Access Compliance Report

Public Rights-of-Way

(Pedestrian Signals)

Intersection ID: N/A	Main Street:	Cross Street: N/A	Location: N/A
ADA ID: 9D970C46FB37	Signal Type: One Push Button-APS	Overall Compliance: No	Severity Score: BTN 1: N/A BTN 2: N/A No BTN: N/A
Codes/Mitigation Info/Possible Solution		Field Measurements/Component Compliance

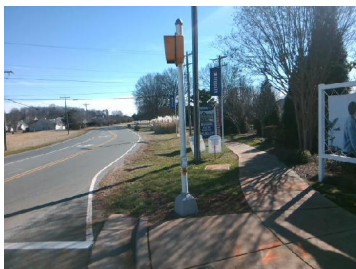
Possible Solutions: Remove & Replace
Replace APS Button With New APS Button.
Remove and Replace Clear Space.

PROW/ADA: R404.2, R404.3, R404.7.2,
R209.1, MUTCD 4e.10
